AGENDA
Cascade Charter Township Planning Commission
Monday, September 9, 2019
7:00 pm
Cascade Library Wisner Center
2870 Jacksmith Ave. SE

STAFF REPORT: Case #19-3546
REPORT DATE: August 29, 2019
PREPARED FOR: Cascade Charter Township Planning Commission
MEETING DATE: September 9, 2019
PREPARED BY: Steve Peterson, Planning Director

STAFF REPORT: Case # 19-3534
REPORT DATE: August 29, 2019
PREPARED FOR: Cascade Charter Township Planning Commission
MEETING DATE: September 9, 2019
PREPARED BY: Steve Peterson, Planning Director

TO: Cascade Charter Township Planning Commission
FROM: Steve Peterson, Community Development Director
REPORT DATE: August 29, 2019
MEETING DATE: September 9, 2019
CASE: #18-3507/Thornapple Pointe Subdivision

14' Sidewall
3' 10" Midpoint
17' 10" Building

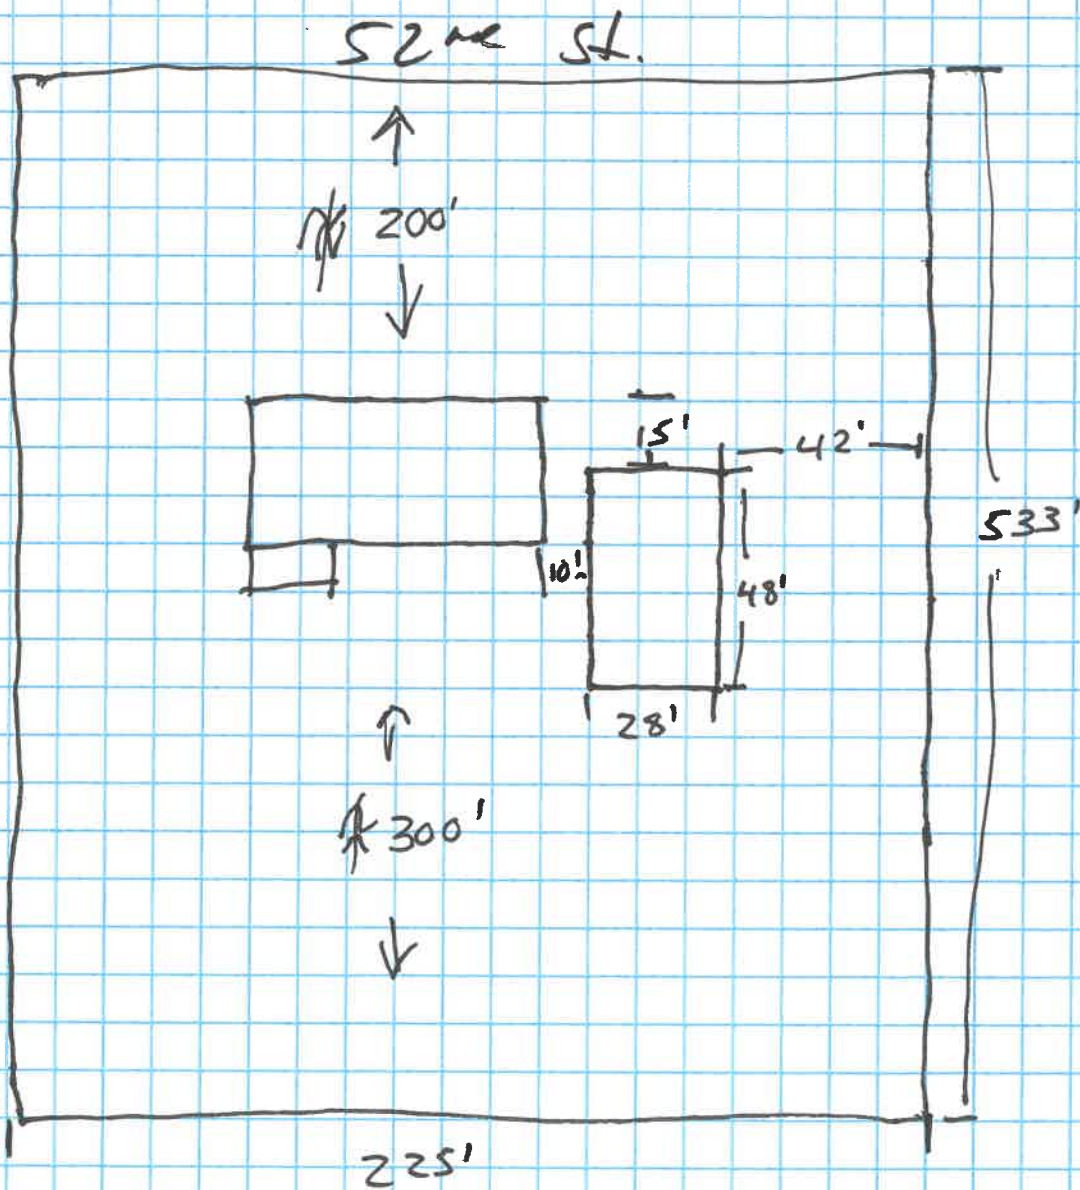
2. This requires a minimum of a 40-foot setback from the side and rear property lines. The applicant shows the nearest property line is 42 feet away. The building will also need to be a minimum of 10 feet away from the house too.
3. With less than 3 acres this is the only accessory building permitted.
4. They have indicated that they want the building for storage of a motor home.
5. The size of the building is “normal” for the area.
6. The building is planned to have metal siding and roofing. This is not unusual in the more agricultural areas of the township.
7. Any outdoor lighting will have to meet our standards, requiring it to be shielded and downcast or at a level that is exempted.
8. It should be noted that accessory buildings cannot be used for living space or to run a business.

UTILITY PLAN
 THE LEARNING EXPERIENCE - 5333 CASCADE ROAD SE
 FOR CASCADE TEL LLC
 1800 FERRIS STREET
 GRAND HAVEN, MICHIGAN 49417
 IN PART OF THE 1/4 OF SECTION 4, T4N, R10W,
 CASCADE TOWNSHIP, KENT COUNTY, MICHIGAN.

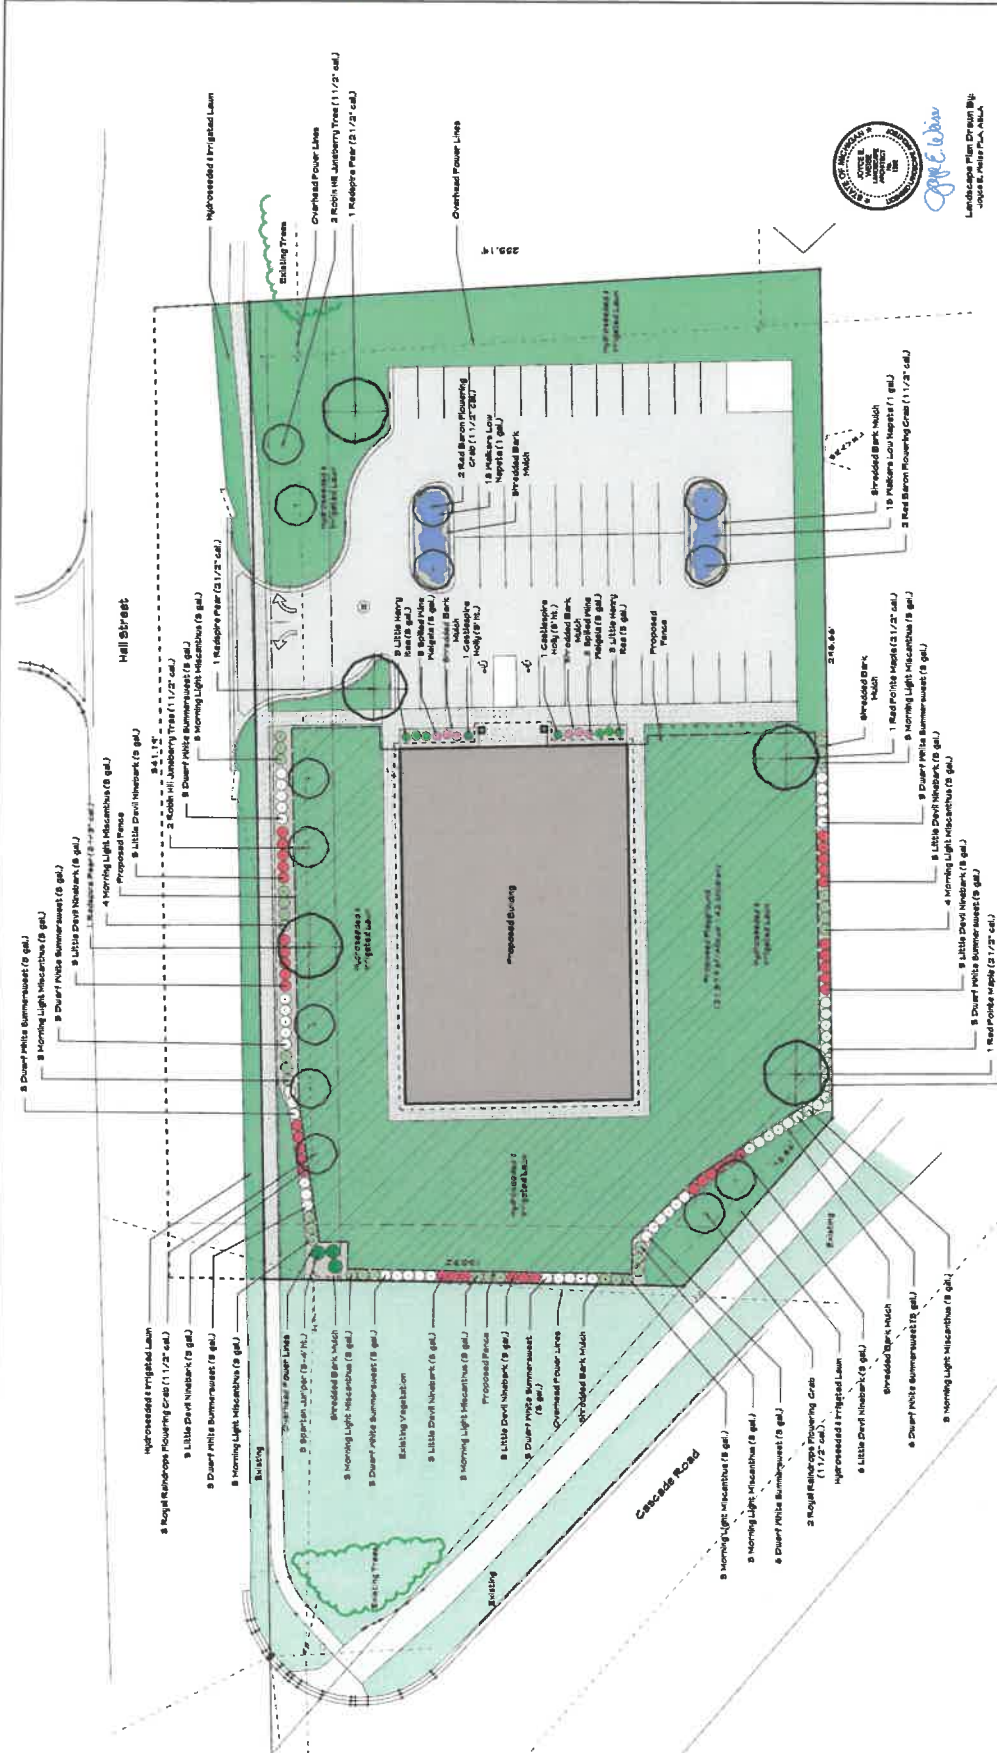
Issue	Response
Approval from the township engineer.	Underground detention system has been moved to under the parking lot and now complies with storm water ordinance.
Revised all plans so they are consistent with the updated site plans.	All plans show the same playground area and have a maximum of 141 kids at the daycare.
Updated lighting plan to include the wall pack lighting.	Photometric plan has been revised to comply with max of 5-foot candles

Not involve uses, activities, processes, materials, equipment or conditions of operation that will be detrimental to any persons, property, or the general welfare by reason of noxious or offensive production of noise, smoke, fumes, glare, vibration, odor or traffic.	This is an accepted residential use, like parks, churches and schools that are also permitted in the residential zone.
...must be situated such that the proposed site has direct primary access on at least one collector or arterial street as classified by the Major Street Plan	The Cascade Rd corridor study suggests that access to Cascade Rd be limited. Providing access off from Hall St would be better from a traffic management perspective.
A minimum lot size of 40,000 square feet.	The site is a little less than 2 acres.
Dormitory facilities are not permitted.	This facility is not a dormitory
Based upon the established capacity of the facility, there shall be provided and maintained, on the premises, a minimum of 150 square feet of outdoor play area per child with not less than 5,000 square feet per facility.	They are now showing a 21,375 sq ft playground area. This provides a maximum of 141 kids for the site. The playground no longer is over the detention system.
